Our ref: <NC05008>
Your ref:

Cambridge Cycling Campaign

East Road improvements

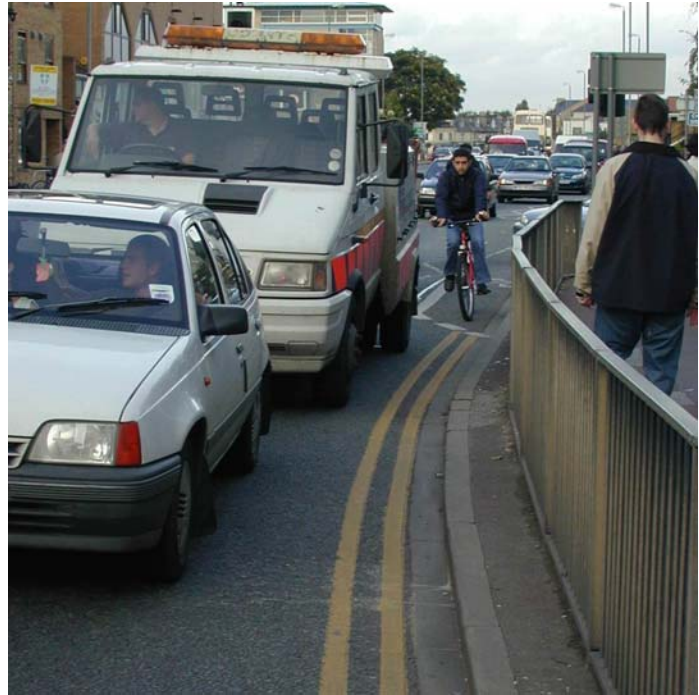
We would like to suggest further improvements to East Road that would fit in well with changes to the crossing at Norfolk Street (see letter NC02007). These would join the piecemeal cycle lanes in East Road into a continuous facility. The current facilities end at pinch points just where they are needed so cyclists can pass stationary traffic in safety.

Firstly East Road in a Southerly direction at traffic light junction with St. Mathews St needs an advance stop line just like the junction with Mill Road.

Continuing in a southerly direction the cycle lane comes to an end at a pinch point just after Norfolk Street. This is exactly the point at which cyclists require most help on the road.

Between Norfolk Street and Broad Street, after the planting on the corner of Norfolk Street the pavement is 3.5 meters wide.

Here we suggest continuing with a 1.5m mandatory cycle lane after the crossing by reducing the width of the pavement slightly.

To do this would require setting back the fence on the planting at the junction with Norfolk Street, but not we believe, require the loss of any shrubs.

After Broad Street we believe the road is wide enough to have a mandatory cycle lane that continues to the advance stop lane at the Mill Road junction.

The mandatory cycle lane that comes from the Mill Road junction just stops, even though the road width here does not narrow. We would suggest continuing the mandatory cycle lane here up to Dover Street.

Between Dover Street and Burleigh Street we would like to see a removal of parking, thus allowing the continuation of the mandatory cycle lane to the existing mandatory cycle lane after Burleigh Street. This is currently a bottleneck for motor vehicles as well as a safety concern for cyclists and there is parking on Adam and Eve Street.

If removal of parking is not possible then we suggest continuing an advisory 1.5m cycle lane along this section. This will be of great assistance to cycles passing queuing traffic during the current 7am-7pm no waiting times.
